**STATE OF TENNESSEE
DEPARTMENT OF TRANSPORTATION**

INSTRUCTIONAL BULLETIN NO. 17-05

Regarding Revised Standard Drawings

Effective June 23, 2017 letting (April 5, 2017 Turn-in), the following Standard Drawings have either been revised to incorporate the new MASH Items Numbers. Also, Chapter 5 of the Roadway Design Guidelines has been revised to incorporate these changes.

**IN-LINE
GUARDRAIL
ANCHOR**

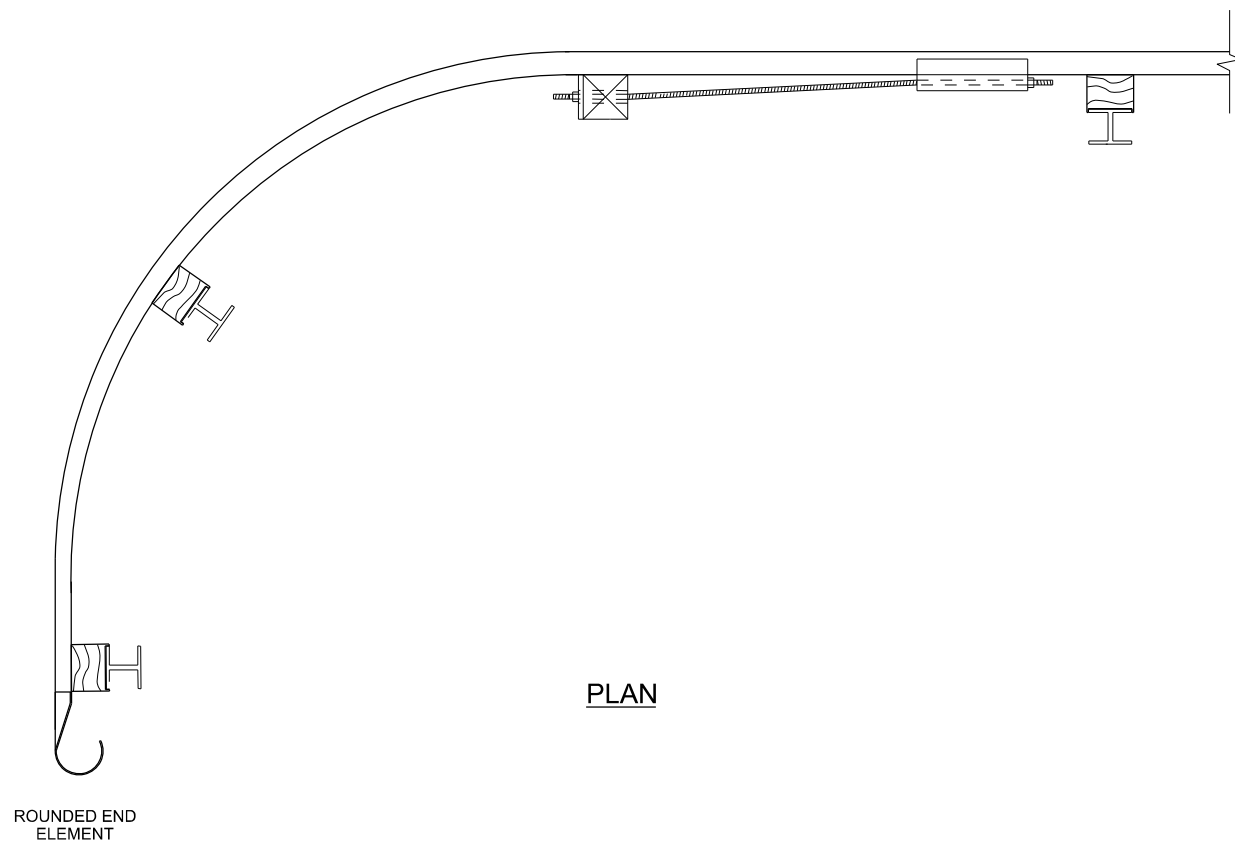
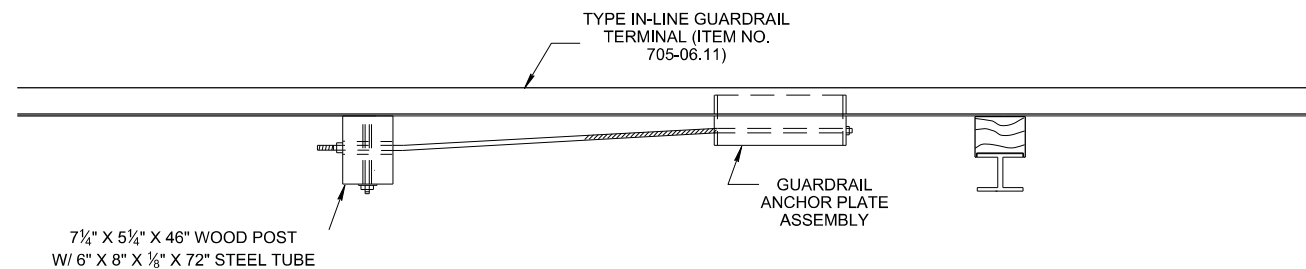
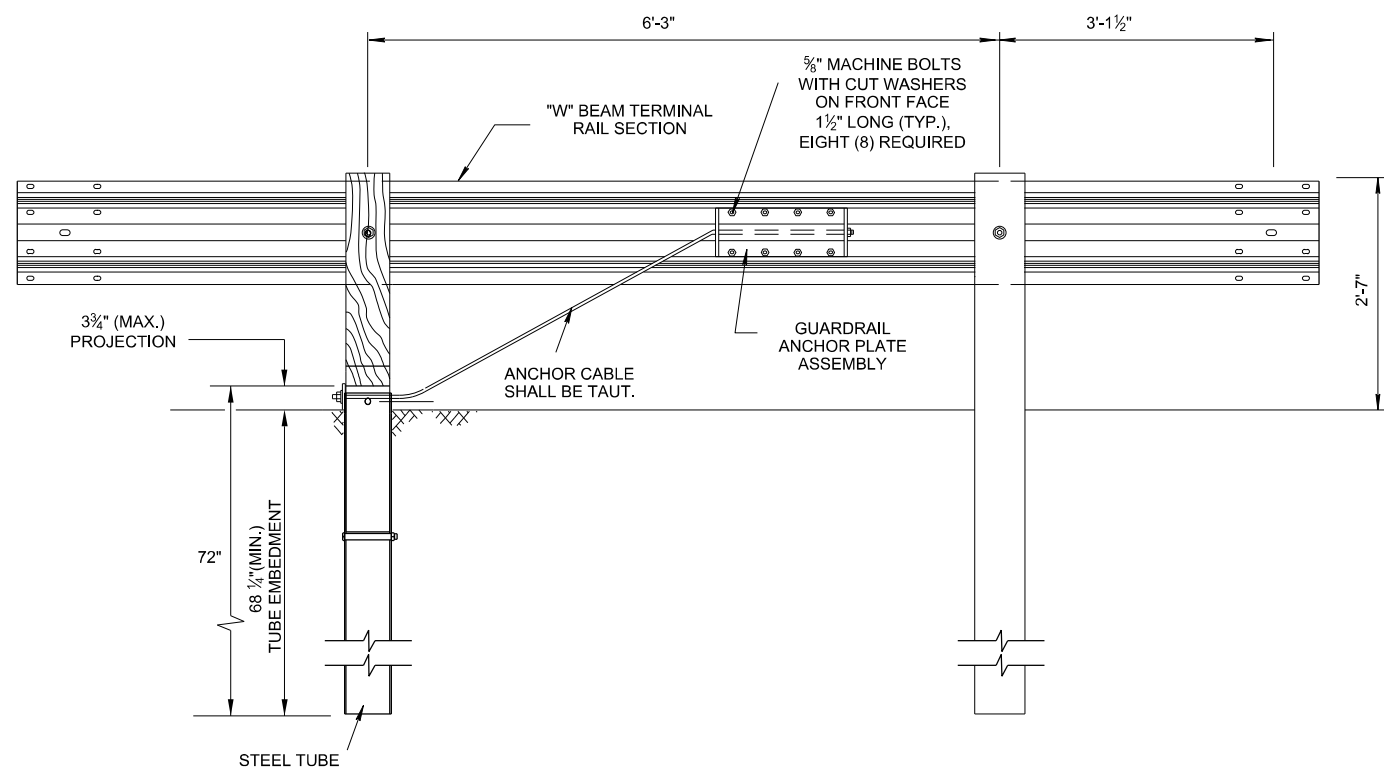
- REV. 5-27-16: REVISED POST SIZE IN PLAN VIEW. ADDED DIMENSIONS. REVISED DETAIL. REVISED NOTES.
- REV. 3-28-17: CHANGED PAY ITEM NUMBER.

SPECIAL CASE
LONG SPAN
GUARDRAIL
ONE POST OMITTED

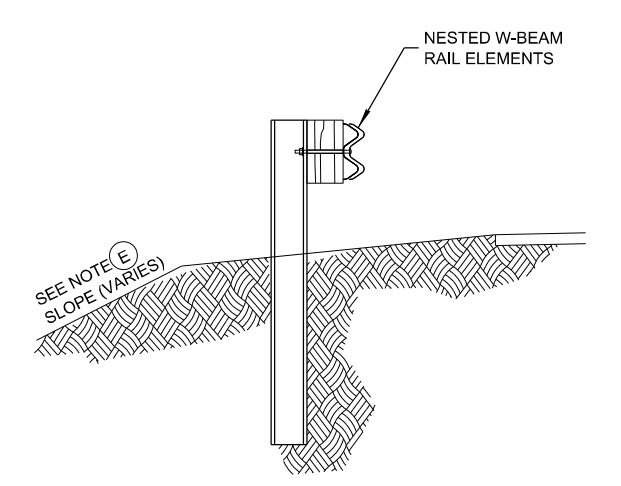
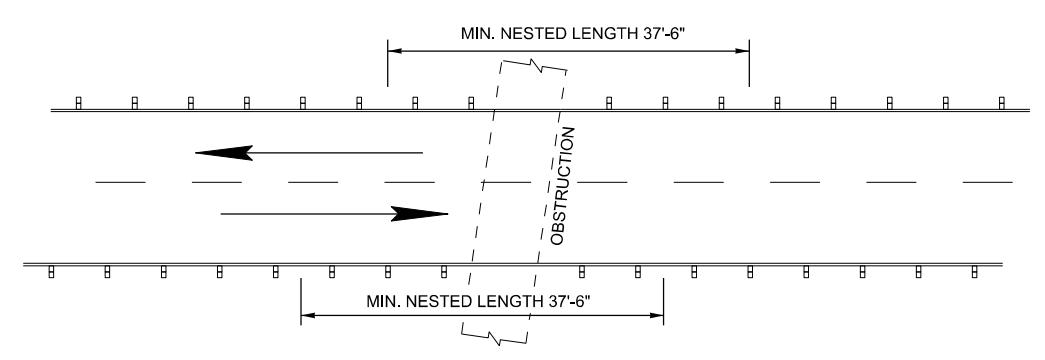
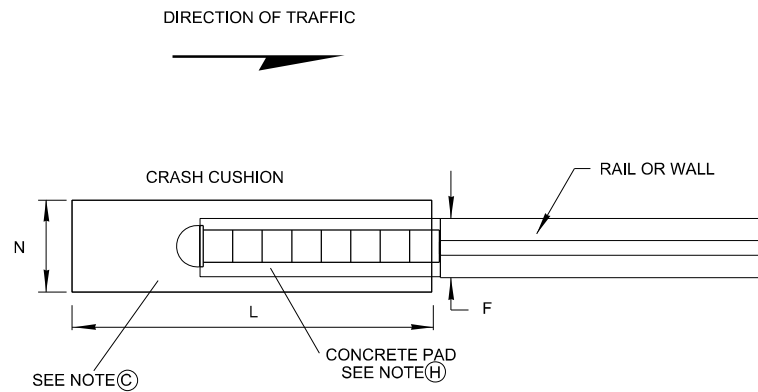
- REV. 1-29-16: CORRECTED PAY ITEM NUMBER.
- REV. 3-28-17: CLARIFIED "RD01-SERIES" TO "RD01-TS-SERIES" IN GENERAL NOTE (E) ADDED NOTE (F) CHANGED ITEM NUMBER IN ELEVATION VIEW.

W-BEAM
GUARDRAIL

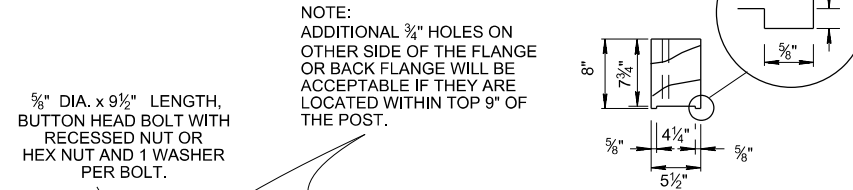
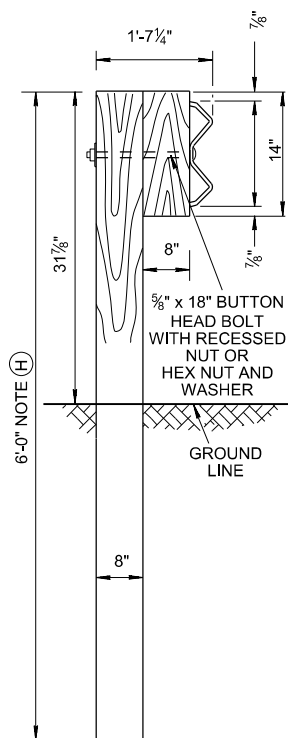
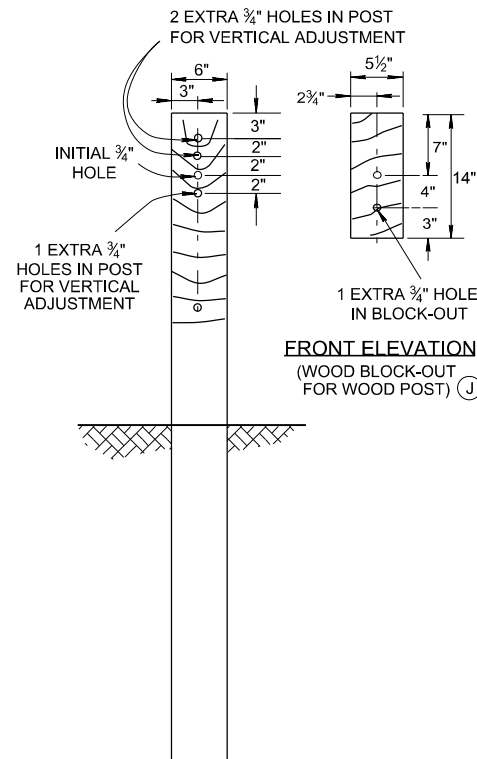
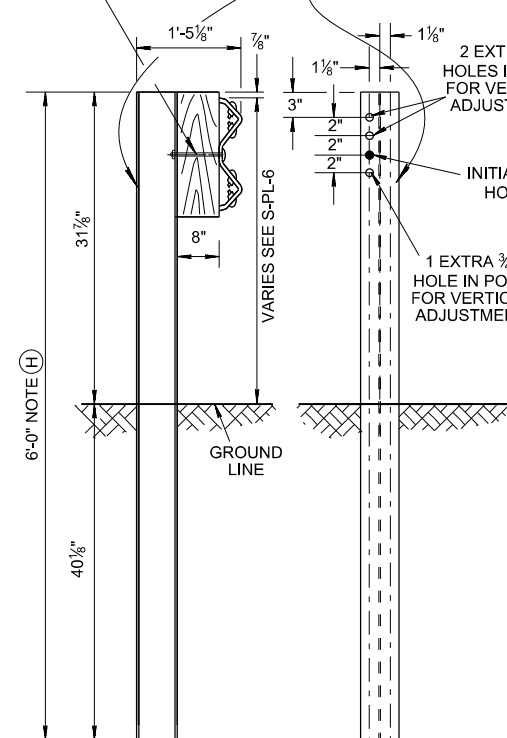
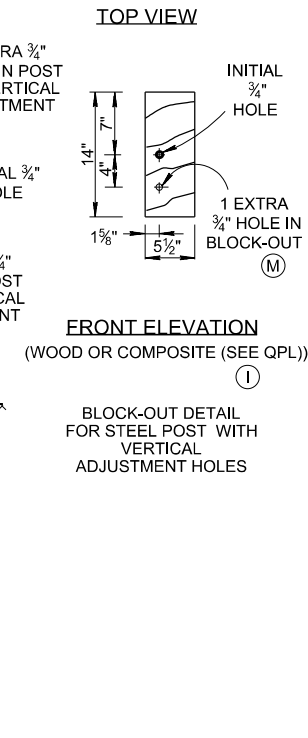
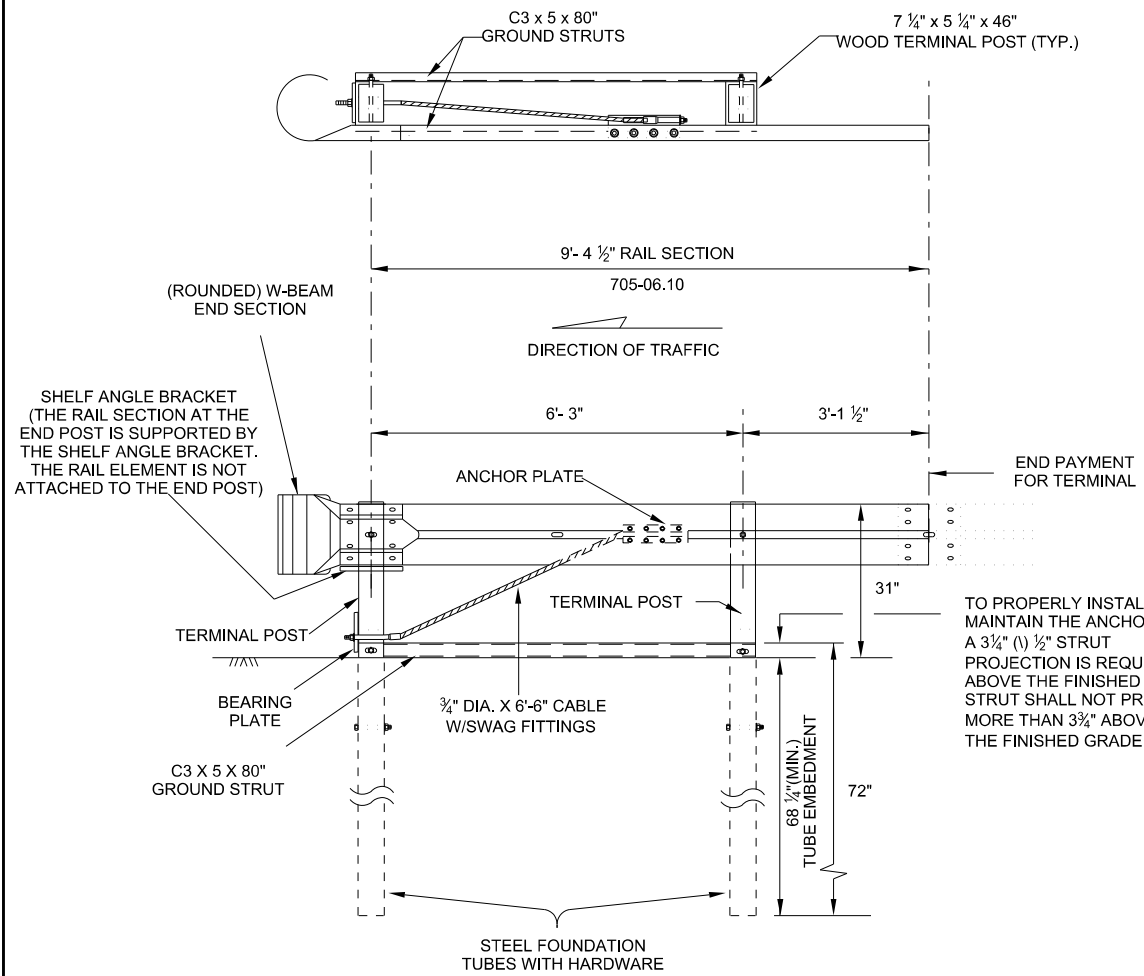
- REV. 12-1-14: REVISED NOTE (L)
- REV. 4-4-16: REVISED NOTES.
- REV. 10-20-16: ADDED NOTE TO ADDRESS ADDITIONAL HOLES.
- REV. 3-28-17: REMOVED NOTE (T) CHANGED PAY ITEM NUMBER IMPROVED POST SIDE VIEWS AND FRONT ELEVATION VIEWS.

**TYPE 13
 GUARDRAIL ANCHOR**

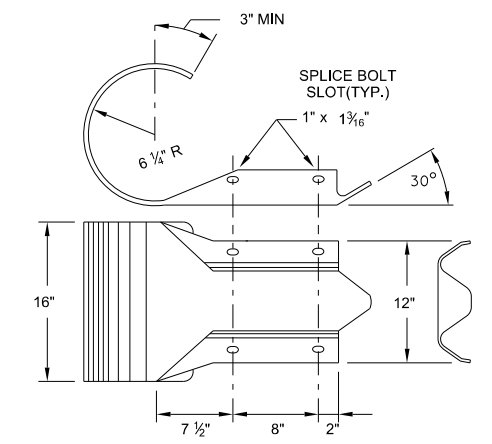
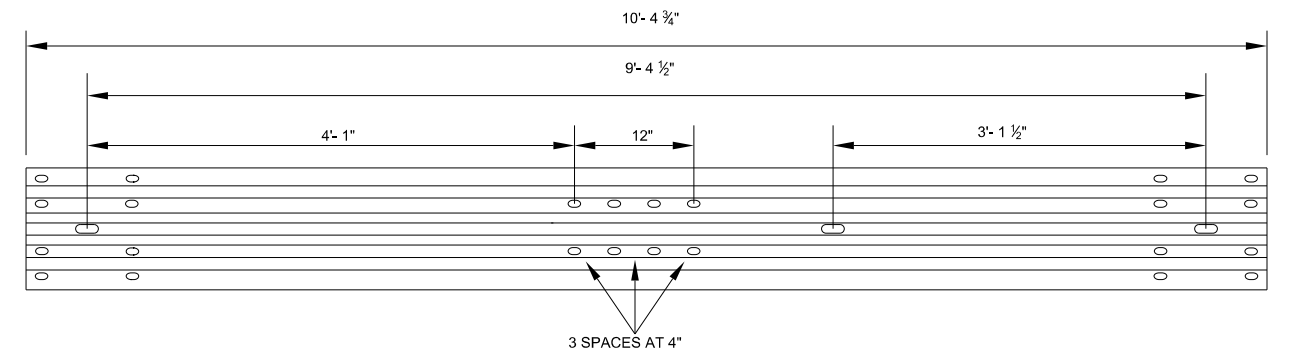
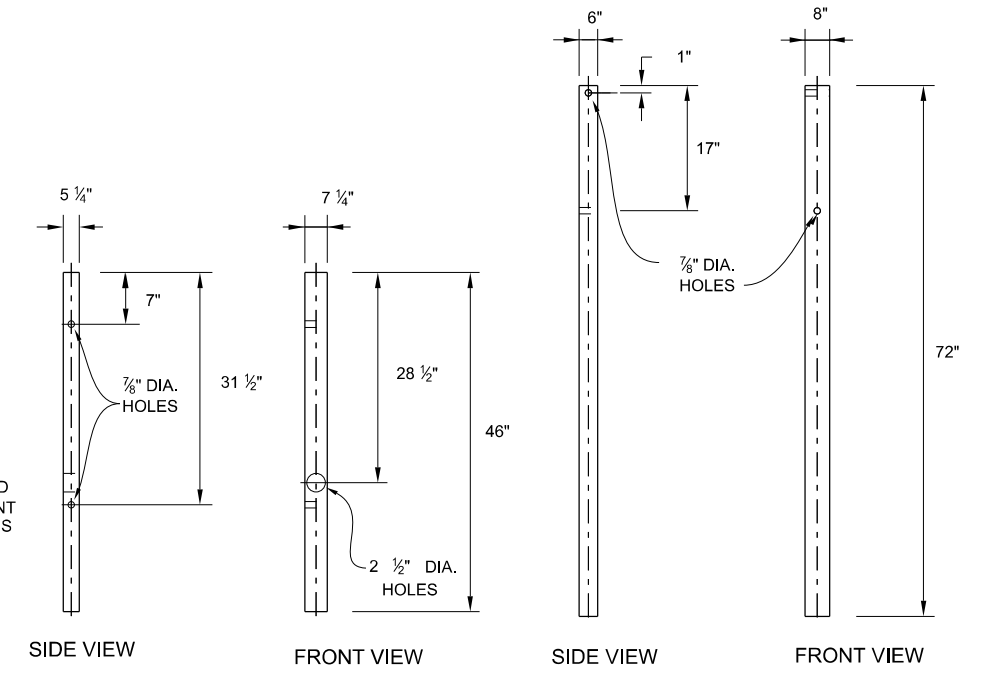
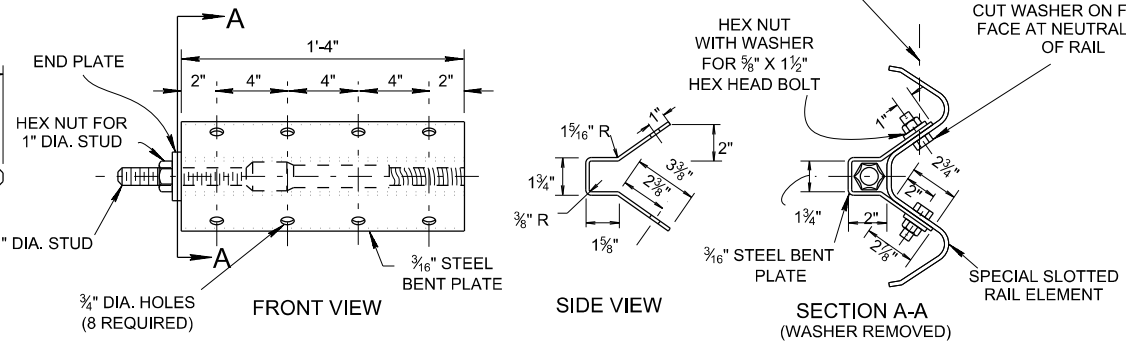
REV. 3-28-17: CHANGED PAY ITEM NUMBER.
 REV. 5-1-15: REVISED NO.1 & 2 BREAK WAY POSTS WITH 5'-0" TUBE SLEEVE.
 REV. 5-27-16: REMOVED TYPE 21 AND IN-LINE FROM TITLE, UPDATED POST DETAIL, UPDATED STRUT DETAIL, ADDED RAIL DETAIL, AND UPDATED NOTES.
